August 21, 2006
LIC-06-0088

**SUBJECT: Fort Calhoun Station, Unit No. 1 License Amendment Request (LAR)
"Change of Containment Building Sump Buffering Agent from Trisodium Phosphate to Sodium Tetraborate"**

**Evaluation for Amendment of FCS
Facility Operating License No. DPR-40**

Figure 2-3

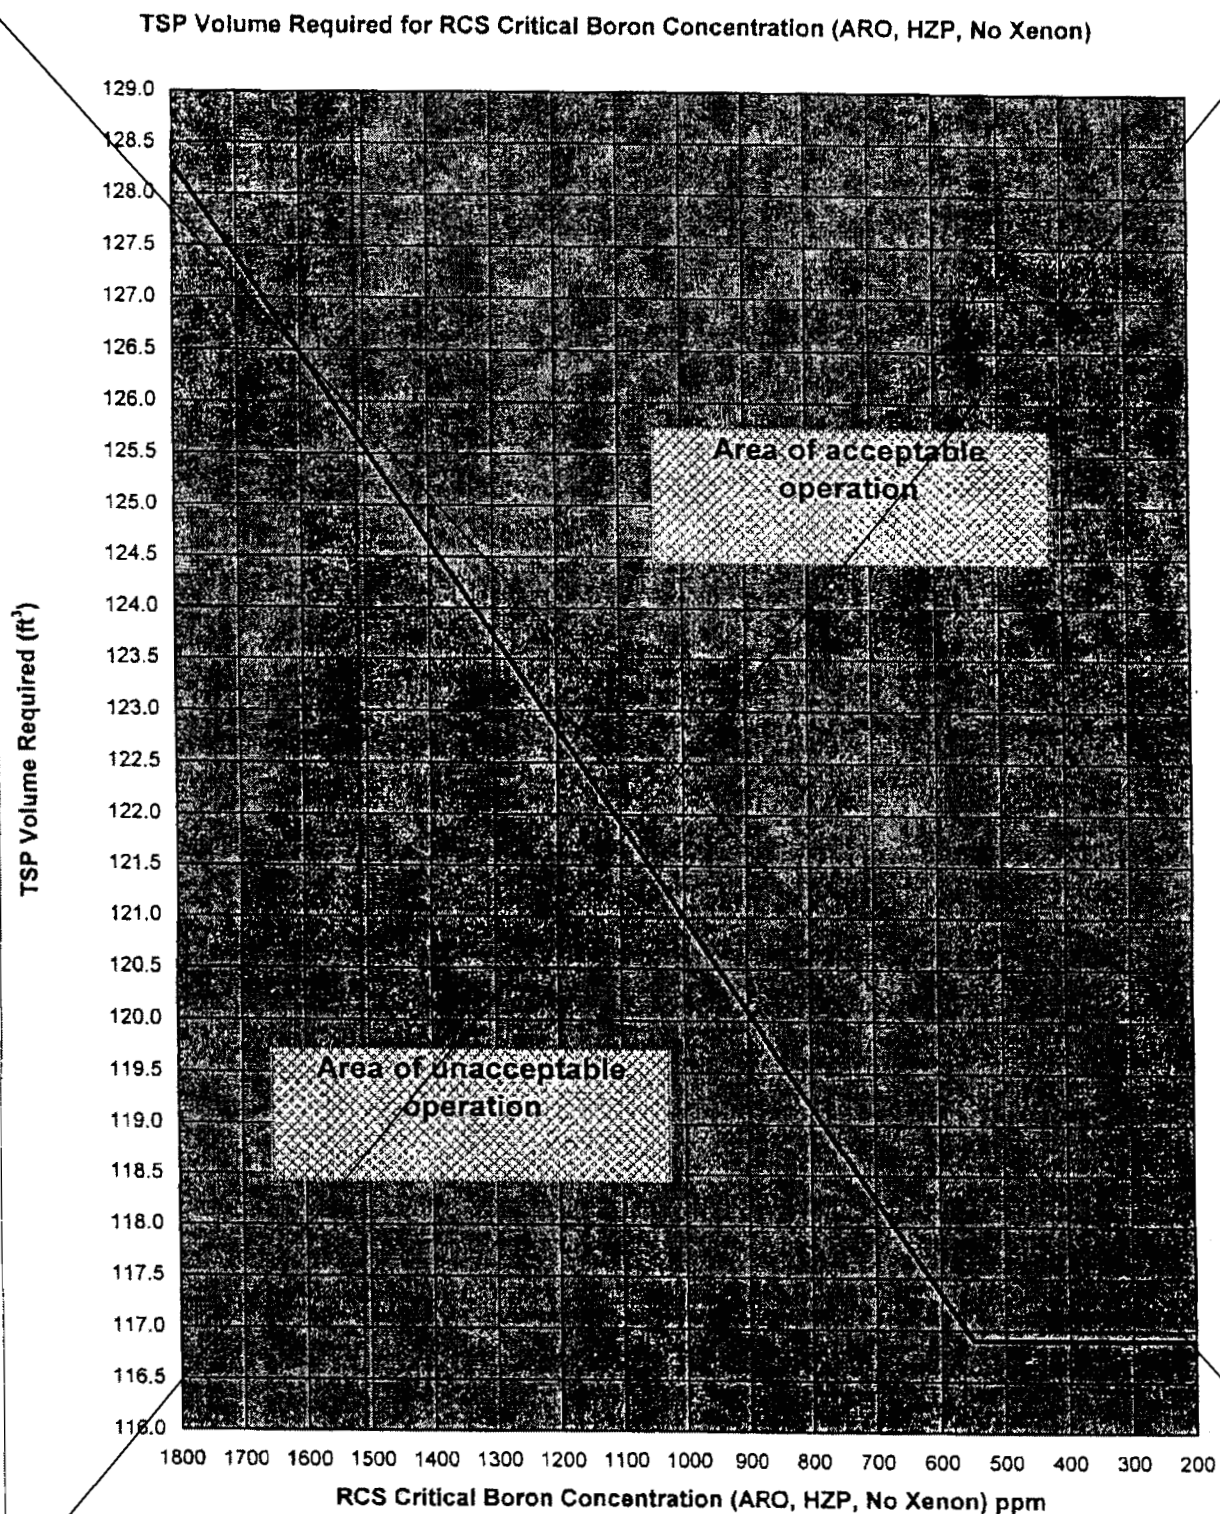
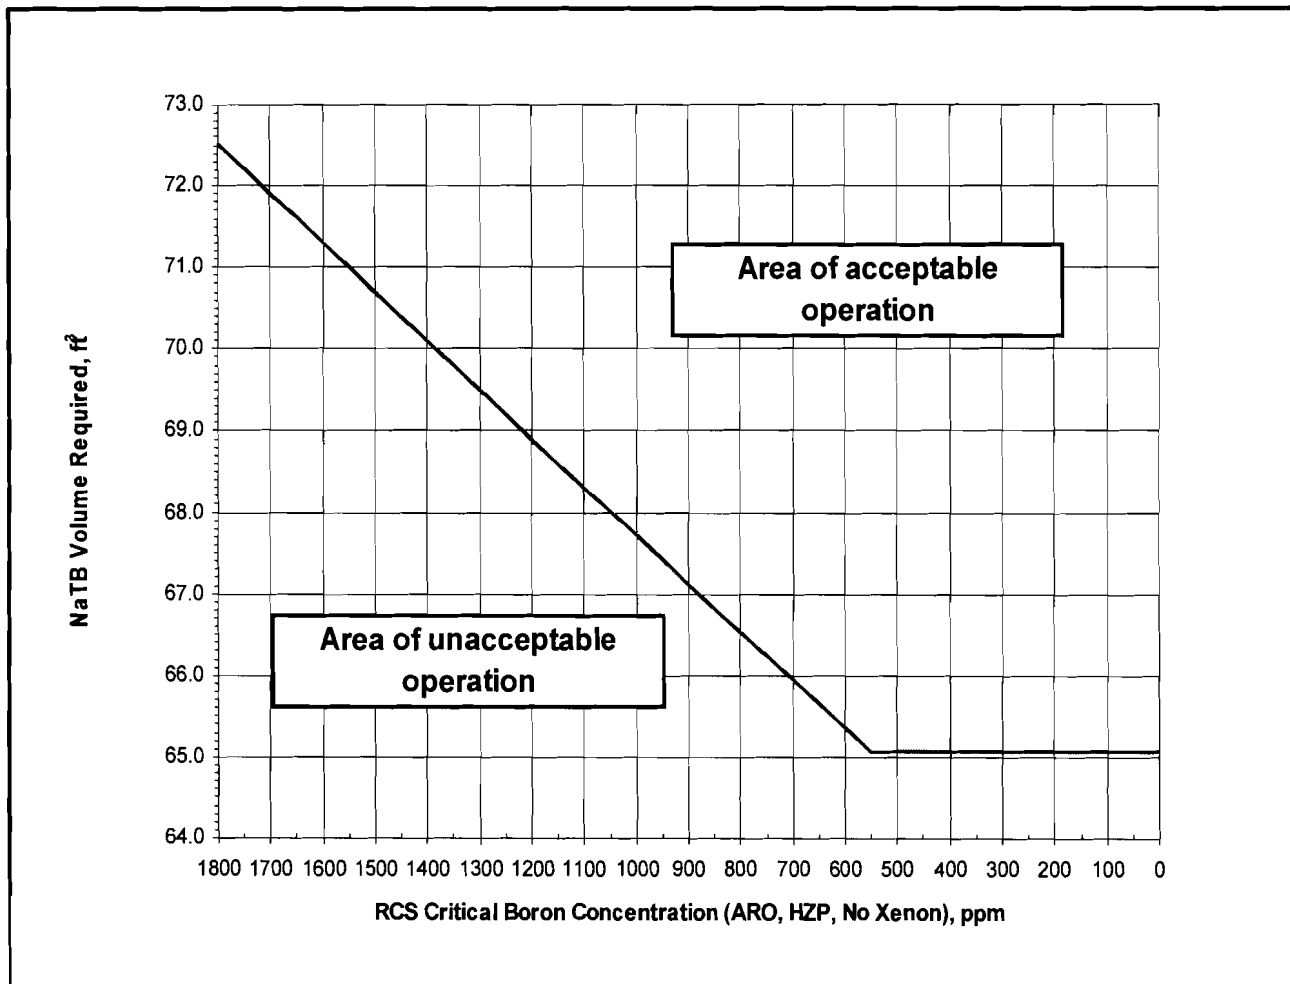
The proposed revision, in addition to replacing TSP with NaTB, modifies Figure 2-3, which shows the minimum required volume of buffering agent versus HZP CBC over the operating cycle, so that it is consistent with the replacement buffering agent. The buffering agent volume requirements outlined in Figure 2-3 bound expected HZP CBC for any operating cycle. Based on historical data, the beginning of cycle HZP CBC is

Figure 2-3 is modified in proposed TS 2.3 to show the areas of acceptable and unacceptable operation for the volume of NaTB required over the operating cycle versus HZP CBC.

TS 2.3(4) is also revised to replace the volume of TSP required for compliance with Figure 2-3 with a revised figure based on the use of NaTB. Figure 2-3 shows the minimum required volume of buffering agent as HZP CBC decreases over the operating cycle. Compliance with the revised Figure 2-3 will ensure that containment sump pH is ≥ 7.0 .

NaTB Volume Required for RCS Critical Boron Concentration (ARO, HZP, No Xenon)
